AUDI OF NOVI JSP21-34

Public Hearing at the request of Lithia Motors, Inc. for approval of the Preliminary Site Plan, Special Land Use Permit, and Stormwater Management Plan. The subject property is approximately 3.91 acres and is located at the northwest corner of Ten Mile Road and Haggerty Road in the B-3, General Business Zoning District. The applicant is proposing to demolish a former Jaguar Car Dealership and redevelop the site in order to build an approximately 11,935 square foot two-story car dealership building to be used by Audi of Novi along with associated parking, vehicle inventory, and site improvements.

PLAN REVIEW CENTER REPORT

Review Date: April 7, 2022
Review Type: Revised Preliminary Site Plan
Project Name: **JSP 21-34 Audi of Novi**
Plan Date: March 9, 2022
Prepared by: Christian Carroll
Contact: E-mail: ccarroll@cityofnovi.org Phone: 248.735.5607

SHEET
Storm Water Management
Plan

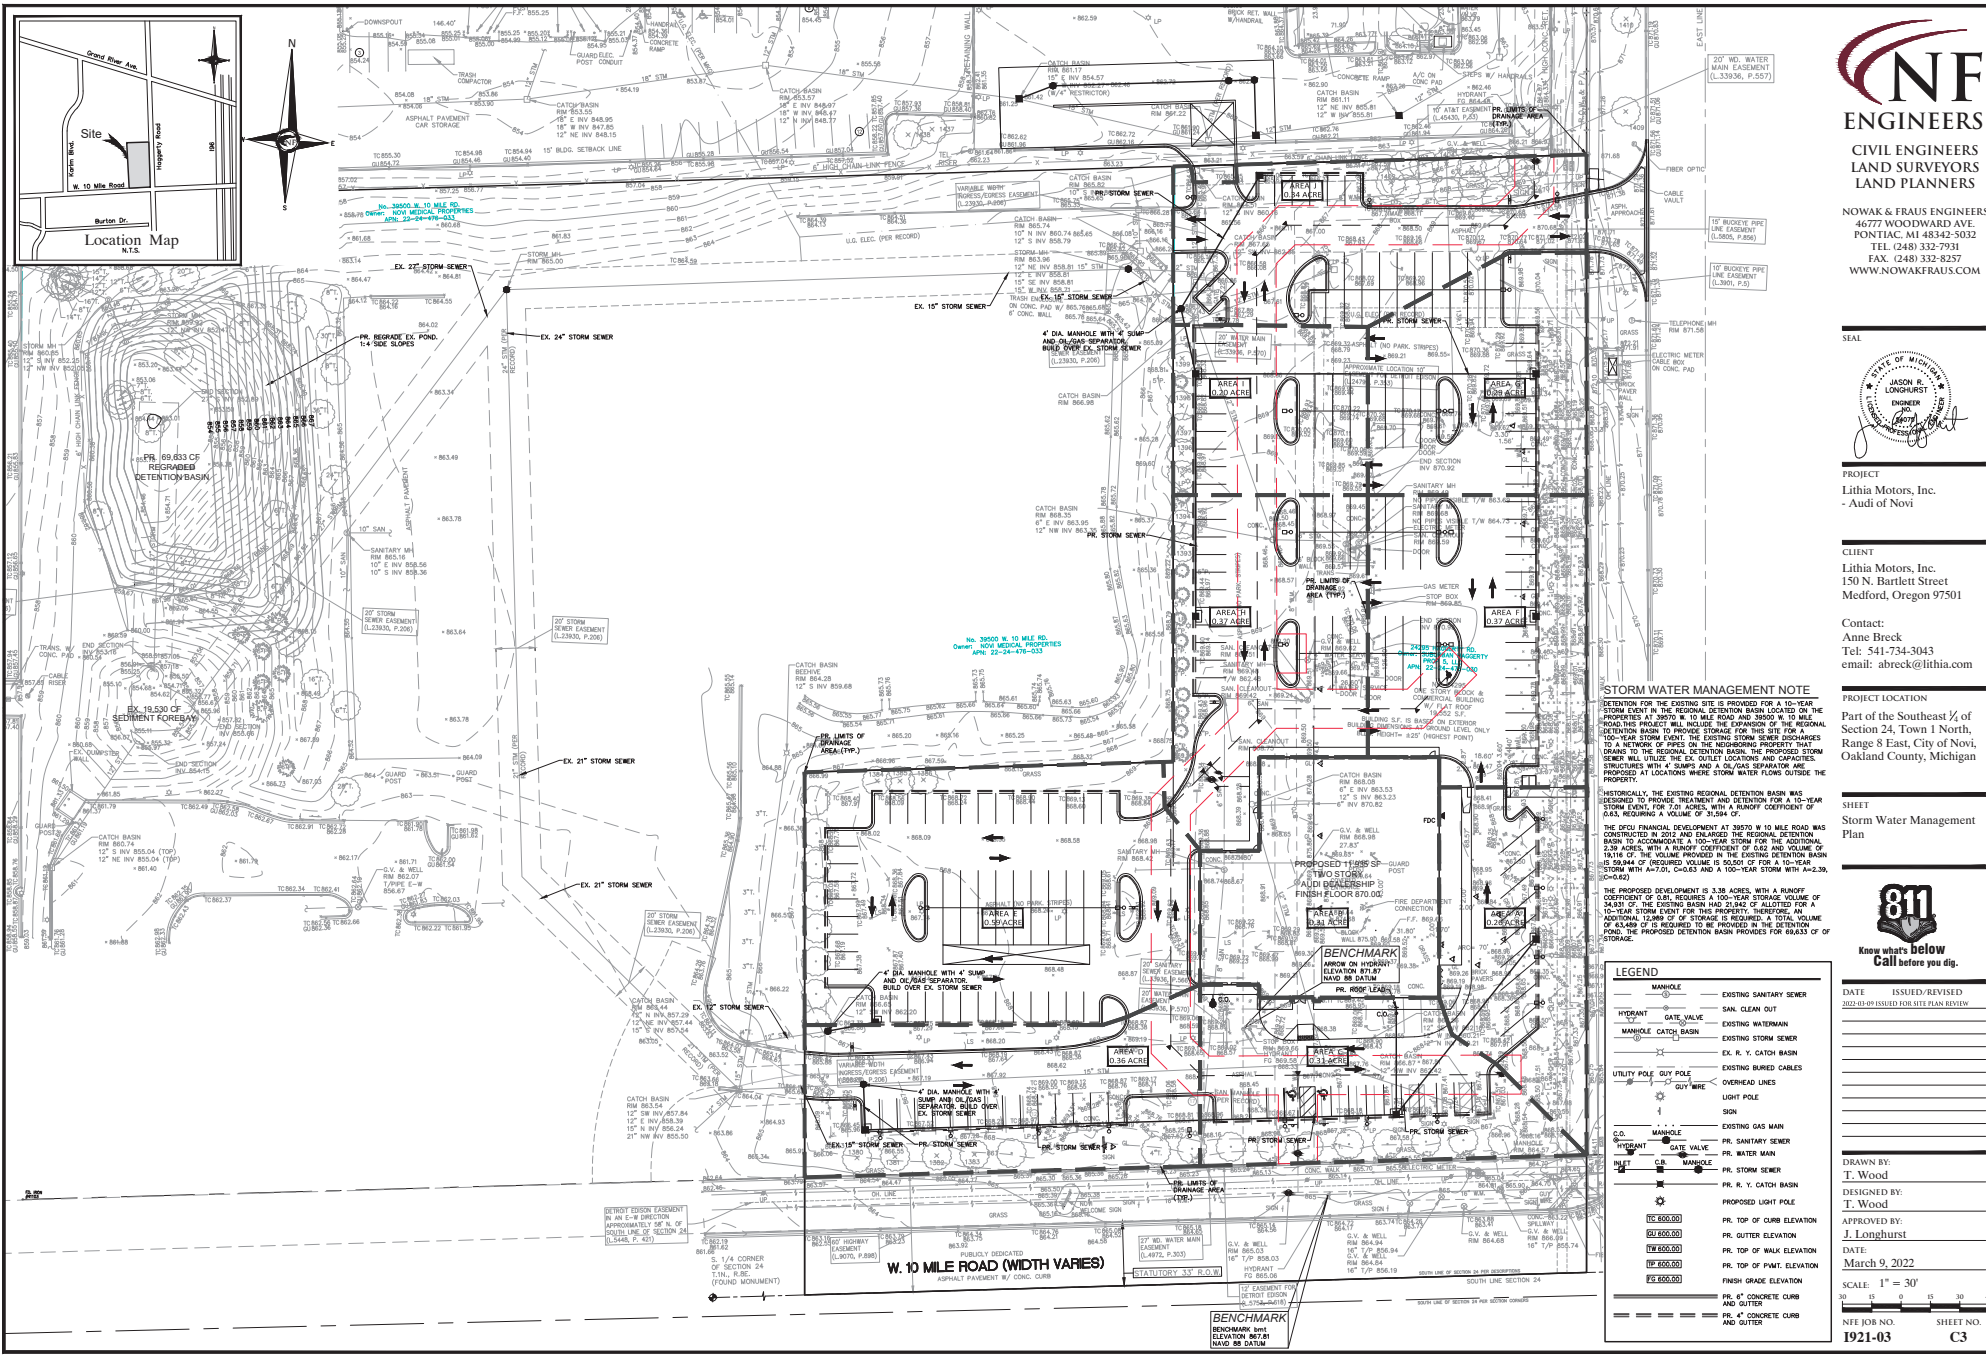
38. LSG as-builts on record show Existing Regional Pond Volume required as 50,710 cu. Ft. (as-built plans emailed with review)
39. The Storm Water Management Plan (SWMP) for this development shall be designed in accordance with the Storm Water Ordinance and Chapter 5 of the Engineering Design Manual.

40. Provide calculations verifying the post-development runoff rate directed to the proposed receiving drainage course does not exceed the pre-development runoff rate for the site.

43. Provide release rate calculations for the three design storm events (first flush, bank full, 100-year).
44. As part of the Storm Drainage Facility Maintenance Easement Agreement, provide an access easement for maintenance over the storm water detention system and the pretreatment structure. Also, include an access easement to the detention area from the public road right-of-way.

45. Provide a soil boring in the vicinity of the storm water basin to determine soil conditions and to establish the high-water elevation of the groundwater table. Note the bottom of the detention facility must be a minimum of three (3) feet above the groundwater elevation.

46. Basin side slopes may not exceed 1 foot vertical to 4 feet horizontal for a dry basin unless fencing is provided.
47. When there is no permanent pool of water, the bottom of all detention basins shall be graded in such a manner as to provide positive flow to the outlet. Use berms or swales to provide positive flow to outlet.

41. There is an existing storm sewer easement on the neighboring property over the existing storm sewer. This is depicted on plan sheet C3 and can be found at liber 23930, page 206.

Plan View
Scale - 1" = 30ft

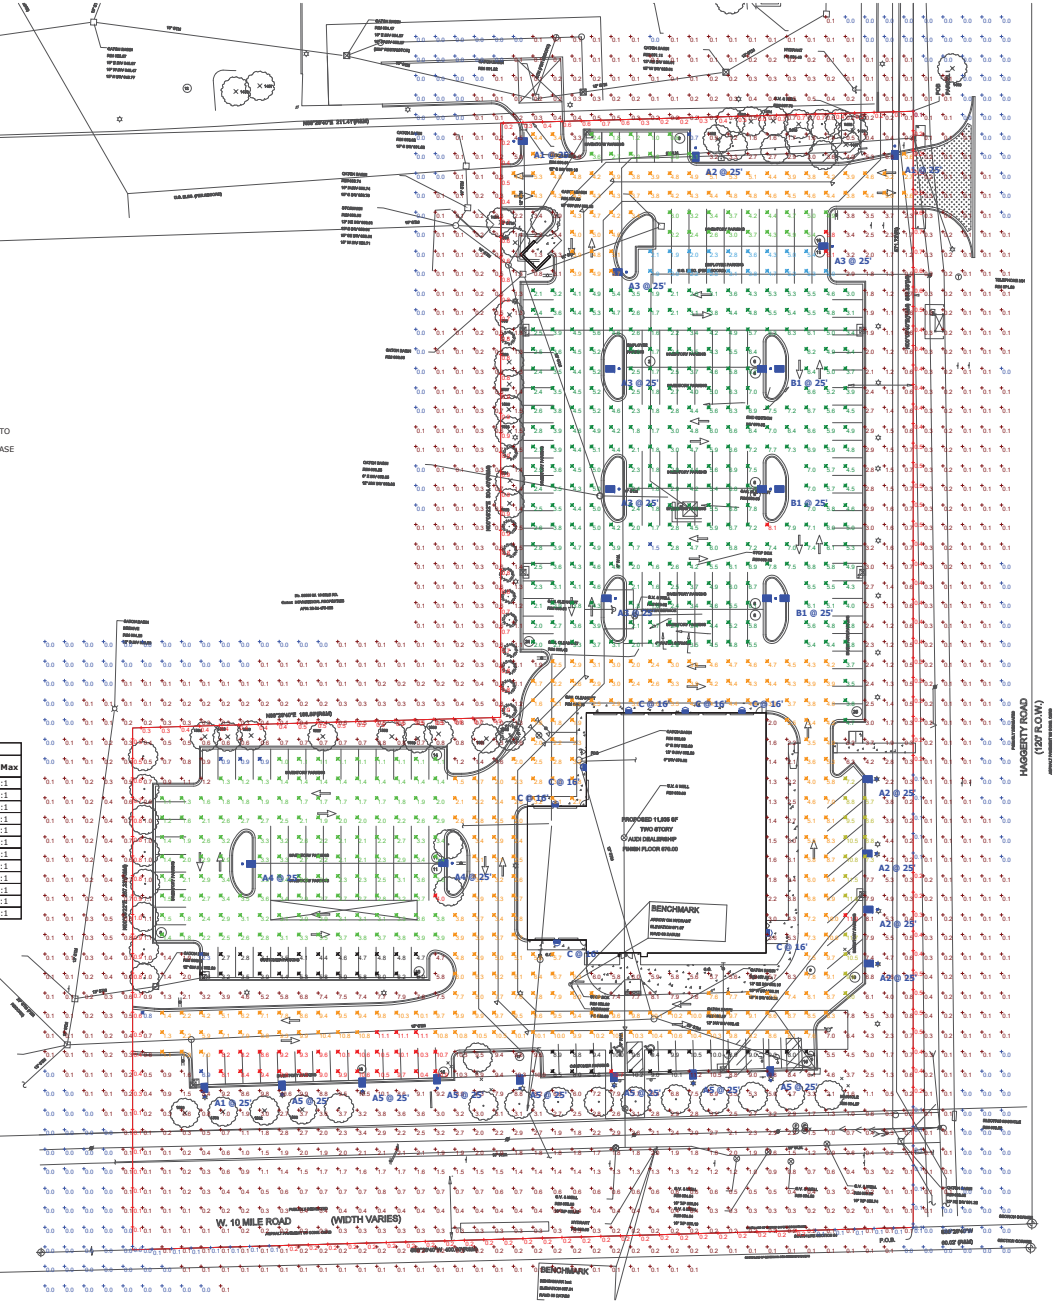
8. Average Light Levels (Sec. 5.7.3.E): The ratio of the average light level of the surface being lit to the lowest light of the surface being lit shall not exceed 4 foot candles to 1 foot candle. **The overall average/minimum light level calculation has not been provided (currently listed as N/A). Please provide this calculation. In addition, the North Inventory Lots and Site Circulation appear to exceed the 4:1 requirement. Please revise, as necessary.**

Item	Required Code	Proposed	Meets Code	Comments
	Photometric plan illustrating all light sources that impact the subject site, including spill-over information from neighboring properties		Yes	
Standard Notes (Sec. 5.7.3.B)	<ul style="list-style-type: none"> - Electrical service to light fixtures shall be placed underground - Flashing light shall not be permitted - Only necessary lighting for security purposes & limited operations shall be permitted after a site's hours of operation 	Notes provided	Yes	
Security Lighting (Sec. 5.7.3.H) Lighting for security purposes shall be directed only onto the area to be secured.	<ul style="list-style-type: none"> - All fixtures shall be located, shielded and aimed at the areas to be secured. - Fixtures mounted on the building and designed to illuminate the facade are preferred 	Note provided	Yes	
Average light levels (Sec.5.7.3.E)	Average light level of the surface being lit to the lowest light of the surface being lit; not exceed 4:1	Not listed	No	Please provide the overall average/minimum light level calculation for the entire site (currently listed as N/A). In addition, the North Inventory Lots and Site Circulation appear to exceed the 4:1 requirement. Please revise, as necessary.

4 SOUTH ELEVATION
SCALE: 3/32" = 1'-0"

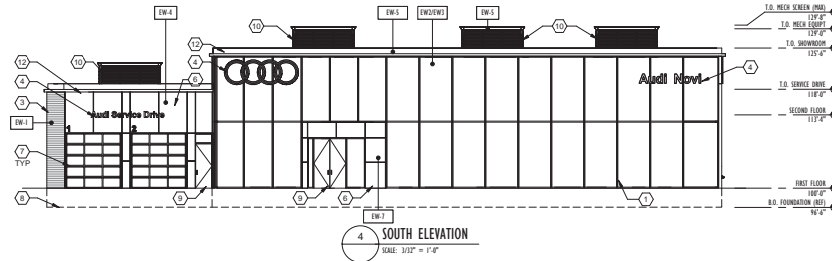
REVIEW	RESULT	DATE	COMMENTS
Planning	Approval recommended	4-7-22	<ul style="list-style-type: none"> • Zoning Board of Appeals Variance from Section 3.10.3.A for an overhead door on the south elevation facing a major thoroughfare (Ten Mile Road). • Parking Setback Waiver of 5.72 feet (10 feet required, 4.28 feet proposed) along the north property line. • Items to be addressed by the applicant prior to Final Site Plan approval
Engineering	Approval recommended	4-4-22	<ul style="list-style-type: none"> • Items to be addressed by the applicant prior to Final Site Plan approval
Landscaping	Approval recommended	3-23-22	<ul style="list-style-type: none"> • Landscape waiver for the lack of a greenbelt berm along Ten Mile Road. • Landscape waiver for the lack of street trees along Ten Mile Road. • Landscape waiver for the lack of greenbelt trees along Haggerty Road. • Landscape waiver for the lack of street trees along Haggerty Road. • Landscape waiver for the lack of a berm or alternate screening for the parking lot along Haggerty Road. • Landscape waiver for a deficiency in building foundation landscaping contingent upon landscaping area provided elsewhere on the site. • Items to be addressed by the applicant prior to Final Site Plan approval

Item	Required Code	Proposed	Meets Code	Comments
	A 10-foot-wide greenbelt planting strip shall be maintained between the street right-of-way line and any area used for customer parking or vehicle display.	20 ft planting strip proposed between the right of way and areas used for customer parking and vehicle display	Yes	
	No major repair or major refinishing shall be done on the lot.	Service area included inside proposed building.	Yes	<i>Note provided.</i>
	All lighting shall be shielded from adjacent residential districts.	No adjacent residential district.	Yes	
	Noise Impact Statement required	Submitted	Yes	
B-3 Business District Required Conditions (Sec. 3.10.3)				
Truck Well and Overhead Doors (Sec. 3.10.3.A)	No truck well, loading dock, overhead door or other type of service bay door shall face a major thoroughfare, nor an abutting residential district. Pedestrian exits or emergency doors are permitted on such building facades.	Overhead doors on south elevation faces a Major Thoroughfare. North overhead doors do not.	No	<u>Applicant is seeking a Zoning Board of Appeals Variance for two overhead doors facing Ten Mile Road.</u>
